PLANNING, ZONING, & BUILDING DEPARTMENT
PZ&B Staff Memorandum: Town Council Development Review

SUBJECT: ZON-23-033 (ARC-23-022) 125 WORTH AVE (COMBO)

MEETING: MARCH 15, 2023

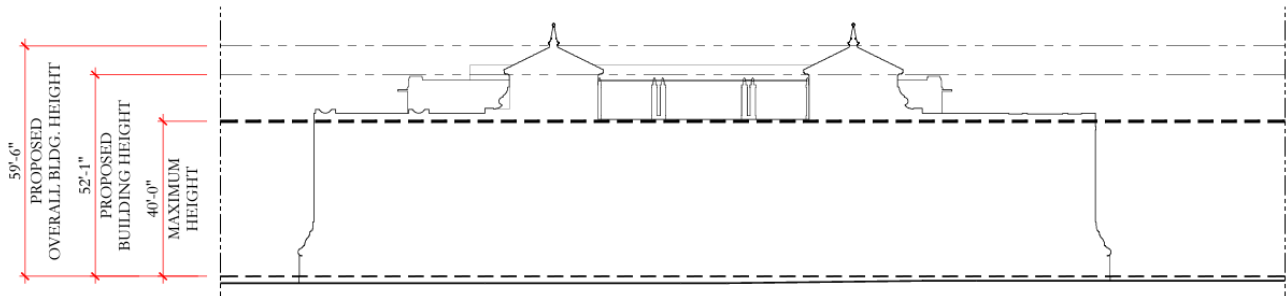
As it pertains to Variance #1, the variance is to reduce the required number of parking spaces by 123 to provide 141 spaces in lieu of the existing 164 spaces and the 264 parking spaces required.

Whereas, if the building were constructed today as proposed, the uses would require 264 parking spaces. Multiple claims by ownership states that the building as it is, is overparked. The applicant has independently performed an Urban Land Institute (ULI) Shared Parking Analysis in order to evaluate actual parking needs for the proposed revitalization plan as submitted evidence as to why the granting of the variance should be considered. The results of the ULI Shared Parking Analysis shows the average peak parking event occurs during many months of the year. The average peak parking event, or maximum demand for parking, requires a total of 164 parking spaces. The ULI Shared Parking Model recommends that the peak parking event be adjusted for the 85th percentile in accordance with the ULI shared parking guidelines. Once the 85th percentile adjustment is applied ($164 \text{ spaces} \times 0.85 = 139 \text{ spaces}$ in the worst-case scenario), the 125 Worth Avenue Parking Plan includes 141 parking spaces which will satisfy the average peak conditions at all times during the year per the ULI Shared Parking Study.

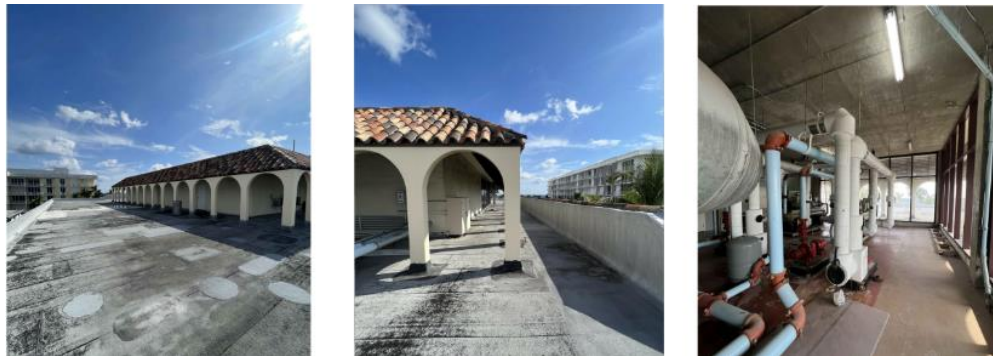
- **VARIANCE #2:** Penthouse/Fourth Floor Addition. The proposed building height (52'-1") and overall building height (59'-6") exceeds the 40-foot maximum height permitted by the Worth Avenue Design Guidelines.

- As it pertains to Variance #2, to exceed the maximum height and building height permitted, the applicant is seeking to expand the existing nonconforming fourth floor. Although this level already exists above the maximum height and overall height, any expansion of the non-conformity requires a variance. This level is stepped back, and the applicant suggests that the visual impacts from the right-of-way will be minimal. Additionally, the applicant has added architectural features such as varied roof types and rooftop projections in the form of finials that exceed the allowable maximum overall height but are standard allowable height exceptions under circumstances where the height is not limited to three (3) stories.

- **VARIANCE #3:** Per Code Section 134-419, a Variance to allow for an expansion of an existing non-conforming building by increasing the existing floor area of the fourth story from 6,785 SF existing to 11,238 SF of enclosed, air-conditioned area.

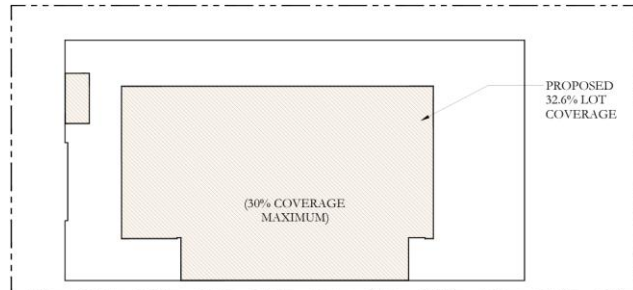
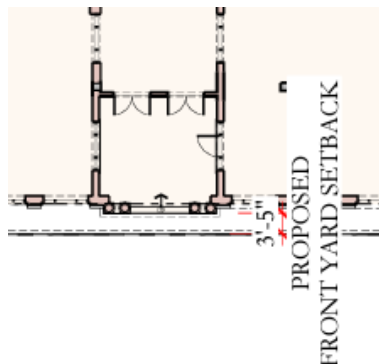
- **VARIANCE #4:** Per Code Section 134-1163(9)c, a Variance to allow Lot Coverage of 32.6% on the fourth floor in lieu of the 30% maximum allowable by the Zoning Code and Worth Avenue Design Guidelines.

As it pertains to Variance #4, the Worth Avenue Design Guidelines prescribe a maximum lot coverage per floor. The Design Guidelines (and the zoning Code) are silent on the fourth floor (hence variance number 3) in the C-WA district, therefore PZB staff applied the highest and most restrictive lot coverage of 30%. The existing fourth floor occupies an area of 6,785 SF (including the loggia), which equates to a lot coverage of 19%. The proposed expanded fourth level totals 11,287 SF for a lot coverage of 32.6%. In excess of the maximum lot coverage, a variance is needed. Worth noting, had the applicant complied with the lot coverage regulation, the size of the proposed fourth floor would be limited to 10,339 SF, or a decrease of 948 SF.

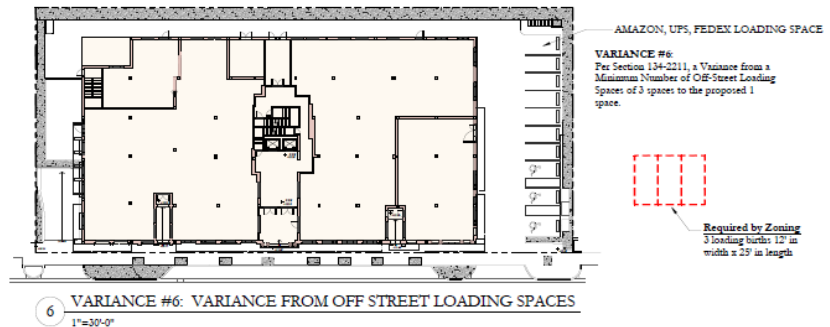
- **VARIANCE #6:** Per Code Section 134-2211, a Variance from a Minimum Number of Off-Street Loading Spaces of three (3) spaces to one (1) off-street loading spaces.

As it pertains to Variance #6, the zoning code prescribes a minimum number of loading bays based on the amount of commercial square footage available in the building. Three (3) spaces are required for buildings which are between 40,001 and 60,000 square feet. The site currently offers zero loading bays, and one (1) new loading space is now being proposed. Although a space is provided where no loading spaces exist, a variance is still required.

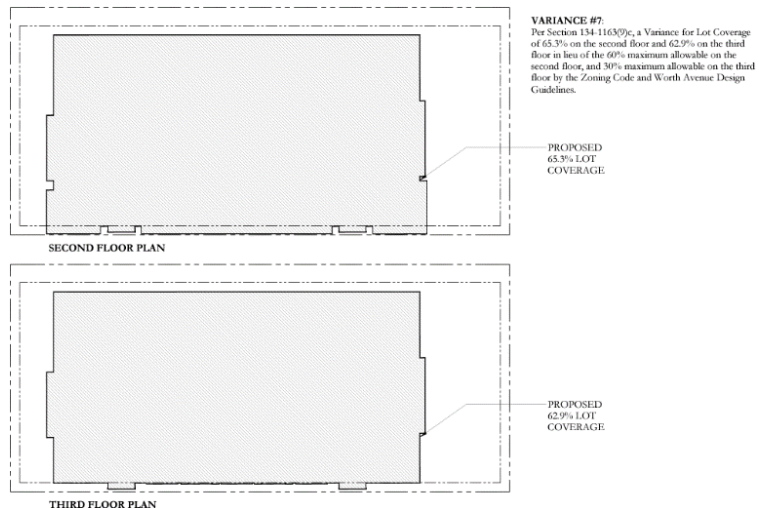
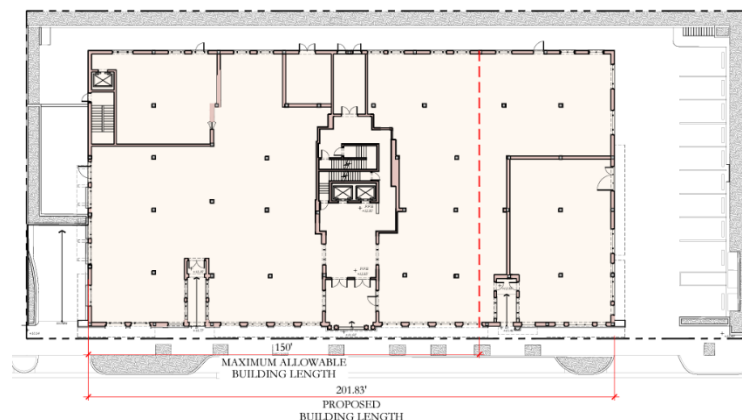
- **VARIANCE #7:** Per Code Section 134-1163(9) c, a Variance for Lot Coverage of 65.3% on the second floor and 62.9% on the third floor in lieu of the 60% maximum allowable on the second floor, and 30% maximum allowable on the third floor by both the Zoning Code and Worth Avenue Design Guidelines.

As it pertains to Variance #7, the applicant is exceeding the maximum amount of lot coverage permitted for the 2nd and 3rd stories. The Worth Avenue Design Guidelines provide an allowance for a greater lot coverage than allowed by right in the zoning code. However, the applicant is still proposing a greater 2nd story and 3rd story lot coverage than the Worth Avenue design guidelines allow. Therefore, a variance is required.

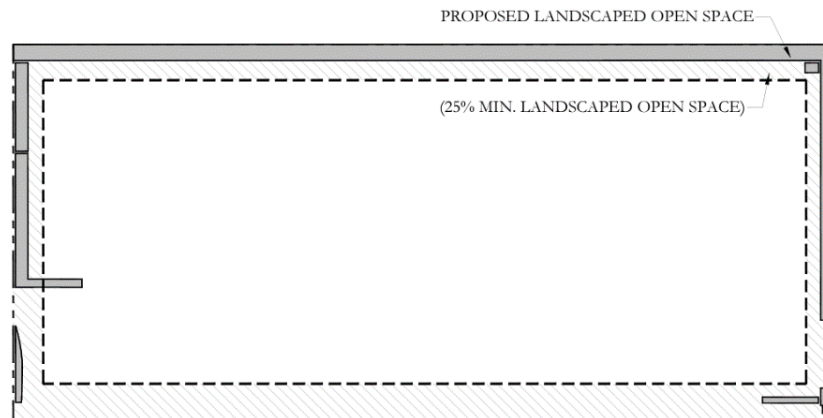
- **VARIANCE #8:** Per Code Section 134-1163(10), a Variance for Maximum Building Length of 201.83 feet in lieu of the 150 feet maximum allowable by the Zoning Code.

As it pertains to Variance #8, to exceed the maximum building length of 150', the applicant is renovating an existing nonconforming building. The ground level frontage length is approximately 166 feet, and with this proposal will increase by 36 feet. Additionally, the building length at the second and third levels is 201.83 feet to add ground level retail that will replace existing surface parking and a drive aisle to provide a more uniform and continuous retail frontage.

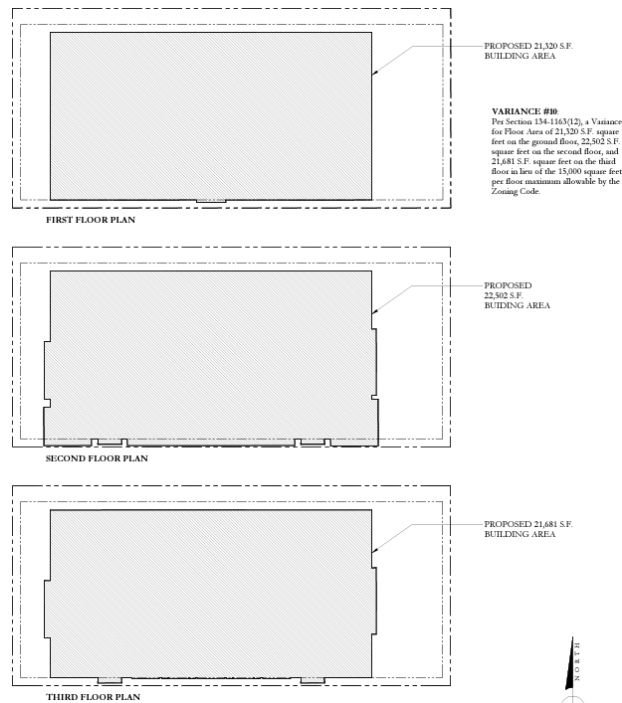
- **VARIANCE #10:** Per Code Section 134-1163(12), a Variance for Floor Area of 65,503 square feet in lieu of the 15,000 square feet maximum allowable by the Zoning Code.

As it pertains to Variance #10, a variance from the floor area maximum, a major component of this proposed project is the complete renovation of the existing building and site—involving a substantial alteration of the existing facade. As such, all nonconforming aspects of the building must be either ‘established’ through the variance process or removed to comport with Code requirements. The existing floor area is legally non-conforming on ground, second, and third floor. The applicant has indicated that the proposed building design will ‘square off’ the building, improve life safety with a new fire stair and elevator, and improve the ground floor urban design.
